BOARD OF ZONING APPEAL

BZA Application Form

LOCATION OF PROPERTY: 18 Clinton St., Cambridge, MA

Raise the base of the foundation of rear portion of structure out of the high water table, resulting in an increase in Height of rear portion of the structure located within setbacks, requiring a special permit.

RENDER - PROPOSED
AND REVISED 3

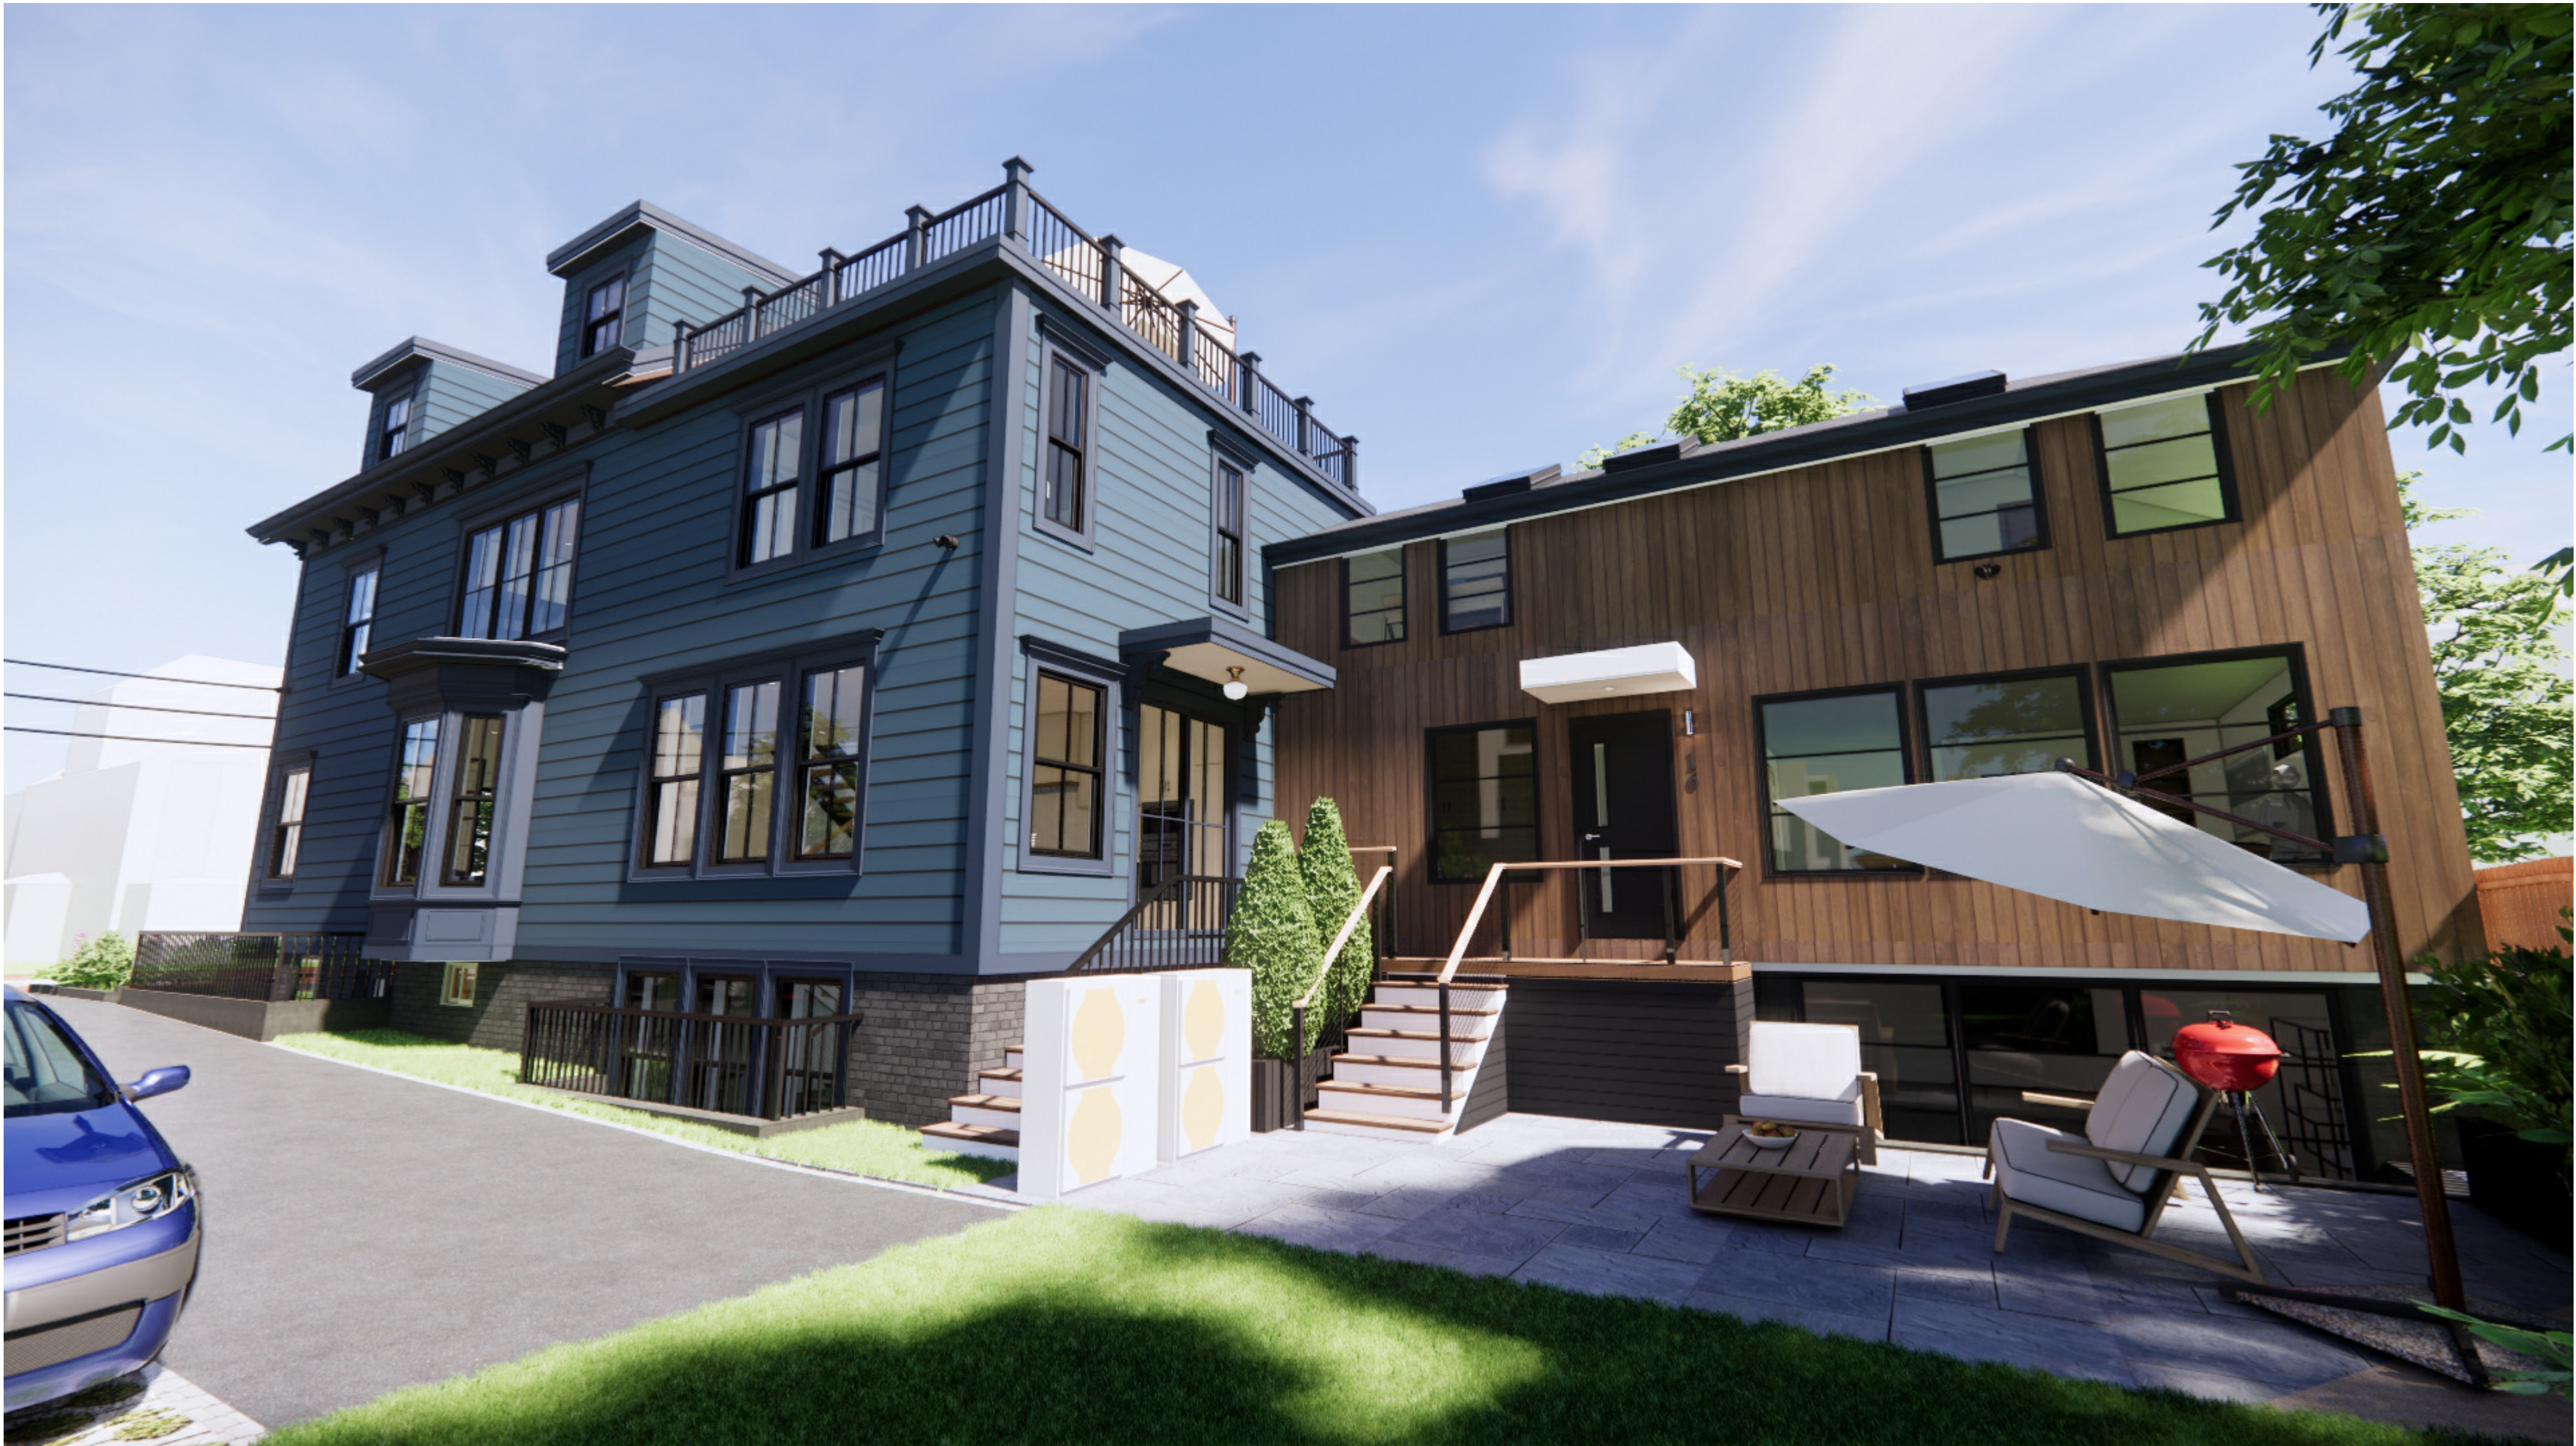
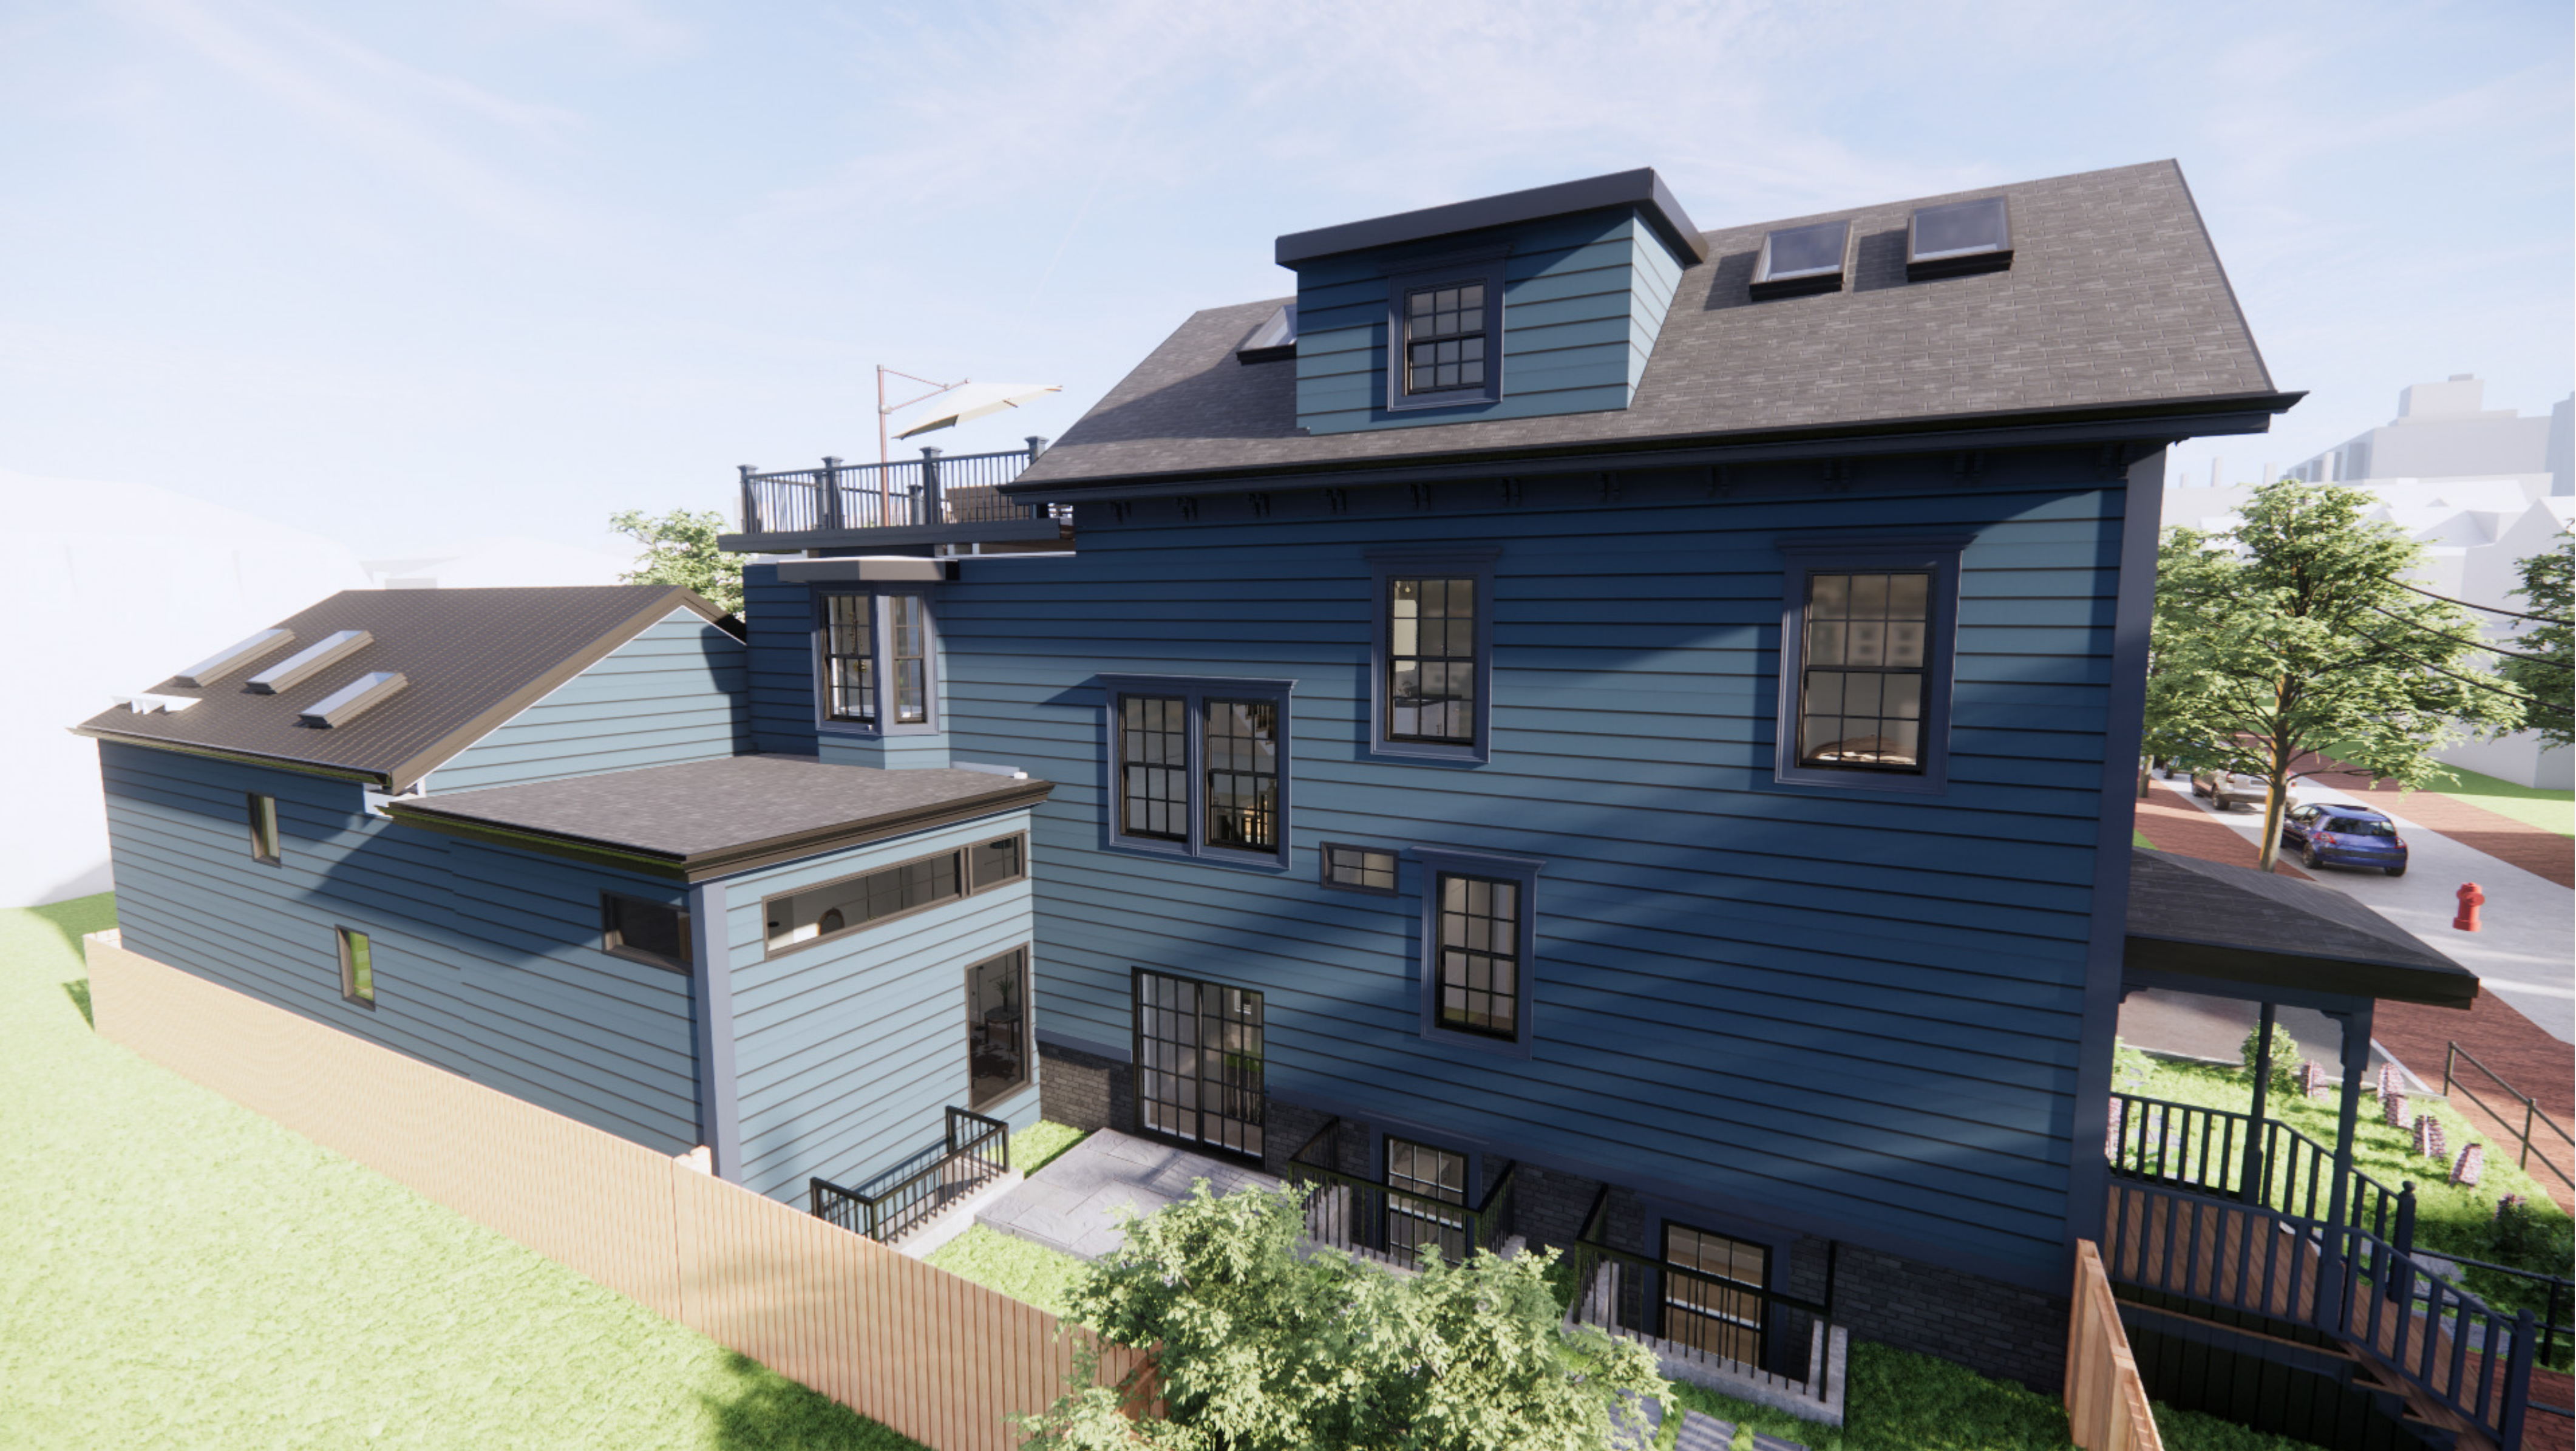
1 You can see here the render of what was the BZA
2 approved. That was the original height of the building. On
3 the el -- in the render below, you can see the new height of
4 the siding, and then with the hip roof that we added on the
5 back, the impact of the siding is not as severe.

Second rendering provided to abutters November 2024

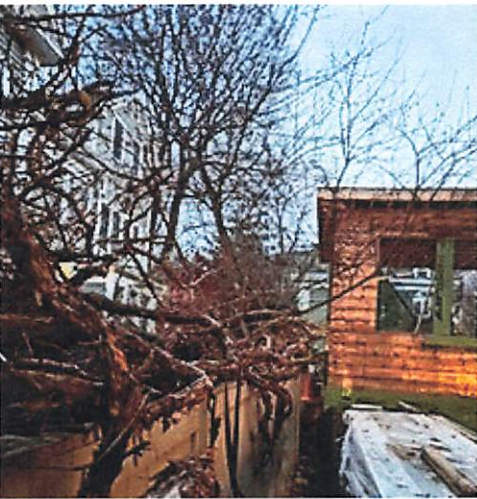
Neither of these renderings illustrate how close this structure would be to our property, and look deceptive, as if trying to hide the lack of space. The actual structure is massive and will overpower the small backyards next to it.

These inaccurate renderings gave us no opportunity to question this before construction, and the second one is for the Board of Zoning Appeal and should not be relied upon, since they do not illustrate the property or the distance to the property line. Also concerning is the distance of the overhanging roof.
